SERVICE BULLETINNO. 4DATE 17.7.87CFM METAL-FAX LTD CONSIDERSCOMPLIANCE - ~~Mandatory/Recommended~~/Optional
(delete which is not applicable)

<u>SUBJECT</u>	UL - REDUCTION GEAR BOX - TORSIONAL SHOCK ABSORBER
<u>MODELS AFFECTED</u>	SHADOW B & B-D
<u>SERIES NOS. AFFECTED</u>	ALL SERIES AIRCRAFT FITTED WITH ROTAX 447
<u>COMPLIANCE TIME</u>	OPTIONAL
<u>PURPOSE</u>	SEE ROTAX SERVICE INFORMATION SHEET ATTACHED - 2 UL 87/E FEB 87.
<u>INSTRUCTIONS</u>	"
<u>MATERIAL REQUIRED</u>	"
<u>AVAILABILITY OF PARTS</u>	FROM CYCLONE HOVERCRAFT LTD.
<u>EFFECTIVITY DATE</u>	N/A
<u>SUMMARY</u>	
<u>NOTES</u>

UL-Reduction gear box, torsional shock absorber - Reduction gear
Configuration with prop shaft in one piece

edition: May 1987

ILL. 1

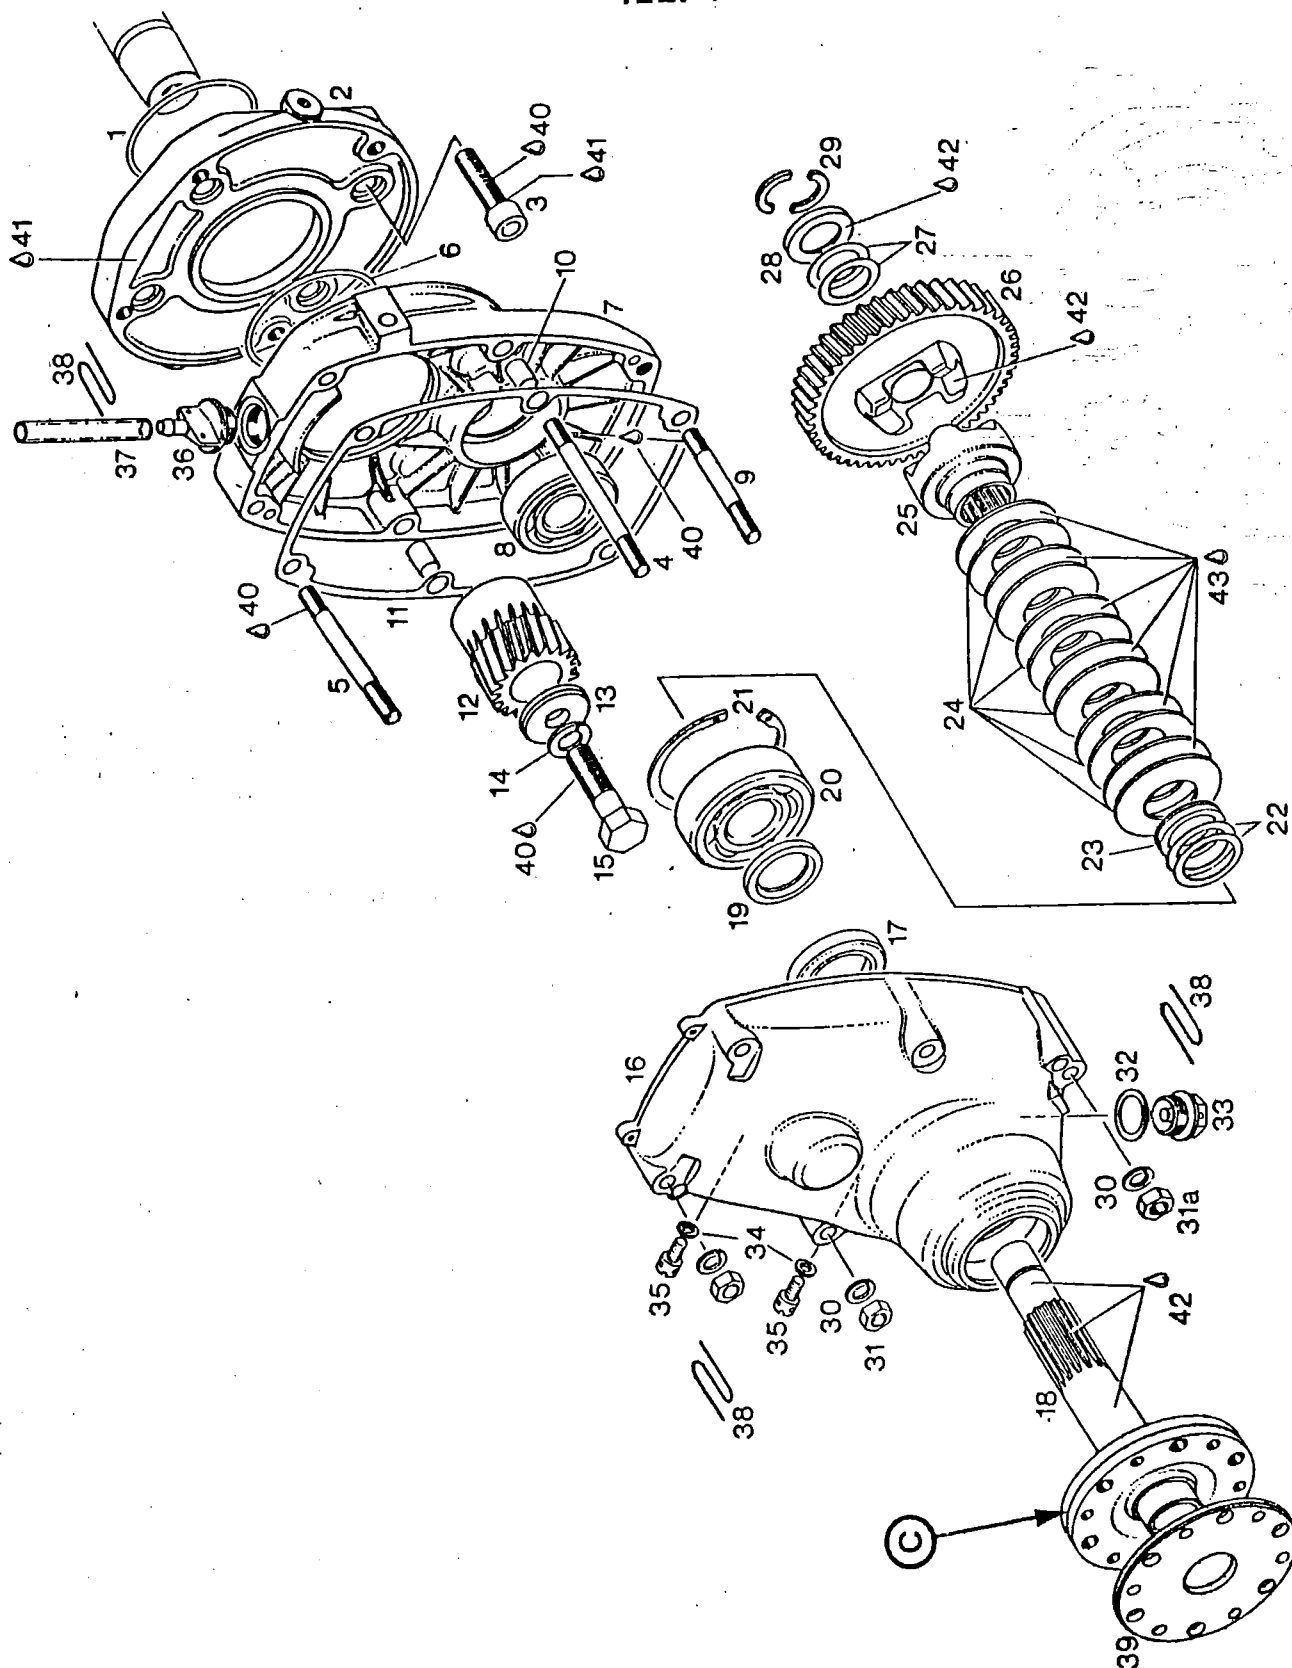
1.3 At a conversion to the 12 spring configuration, a new initial preload setting is necessary. This conversion requires the use of a prop shaft execution with marking groove (C) on shaft flange (see ill. 1).

To prevent metal galling, apply LOCTITE Antiseize at specified positions (item 42) to prop shaft and to dog gear, 4-dog hub and the 2 thrust washers, 0,8 mm thick, (item 27) prior to assembly (see ill. 1 and 4).

ILL. 2

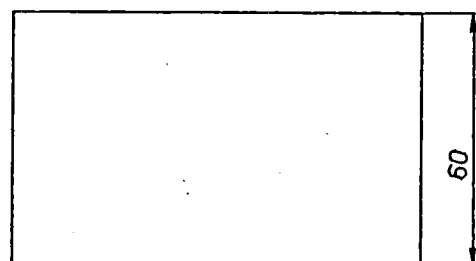
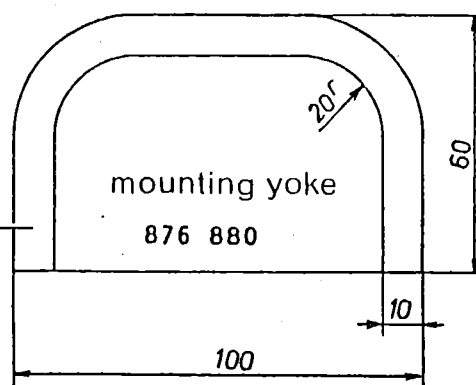
2.15 Place gearbox under hand press (see Ill. 2) and apply pressure via mounting yoke (part no. 876 880) on the dog gear (item 26) until ring halves (item 29) become free and can be taken off.

2.42 Place gearbox under handpress (see illustr. 2) with mounting yoke (part no. 876 880) over dog gear (item 26). Do not use motorized press.

ILL. 3

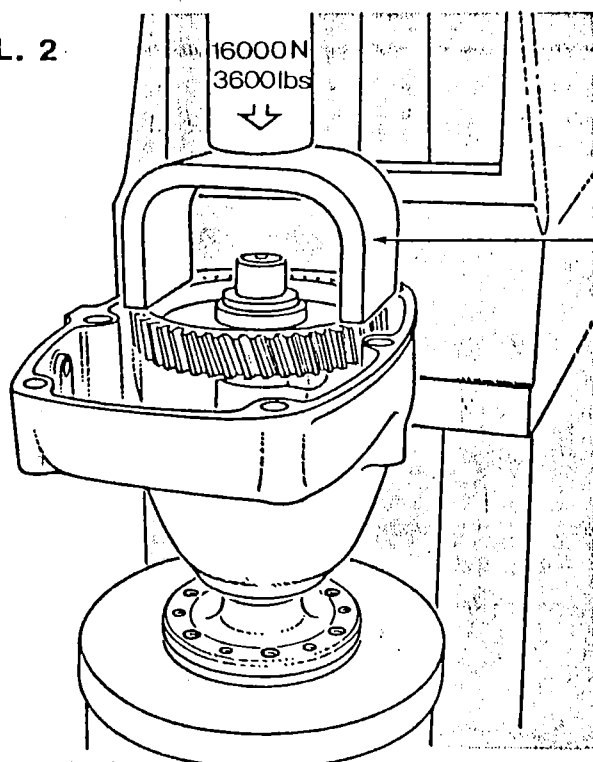
2.21 Clean all parts and check for wear. Examine carefully the groove in the prop shaft for the ring halves (see (D), Ill. 3). REMOVE any burr at edges ensuring that outer shoulder is straight cut. If any doubt exists replace shaft.

2.31 Exchange the 13,7 long distance sleeve (part no. 847 505) for a 4,5 mm thick distance ring, part no. 847 620 (item 23), with one side tapered. To ease recognition of the tapered side see marking groove (B) Ill. 3.

2.43 Place angular ring (item 28) upside down on the prop shaft (see illustr. 3) to facilitate reading of the distance (A).

2.45 At this completely compressed state, the distance between upper side of angular ring to lower edge of groove has to be measured. (see ill. 3). Add appropriate shims between angular ring and dog gear face until bottom is flush with inside groove (D).

2.46 Release the load and compensate the determined distance (A) with shims (item 22) between distance ring (item 23) and bearing (item 20).

ILL. 4

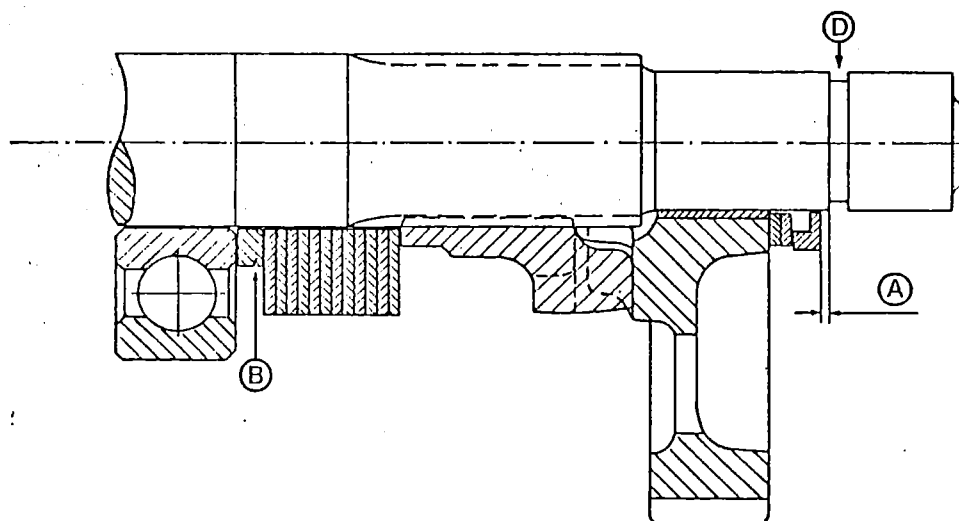
2.33 Use shims as required after determination of preload with sizes from 0,1 - 0,2 - 0,3 - 0,5 up to 1,0 mm (part no. 944 474, 944 470, 944 471, 944 472, 944 473) at location 22 (see para. 2.4 below, also (E) Ill. 4).

2.41 Assemble the distance ring (item 23) with the tapered side (marking groove (B)) towards springs, 12-spring pack (item 24, also (F), Ill. 4), the 4-dog hub (item 25), dog gear (item 26) and the 2 thrust washers 0,8 mm (item 27). Don't yet place any shims (item 22) in position (see Ill. 3).

A t t e n t i o n : Fit disk springs together in pairs, according to illustr. 4 (F).

2.52 Place angular ring to prop shaft with open end upside and coat mating side with LOCTITE Antiseize (see illustr. 4).
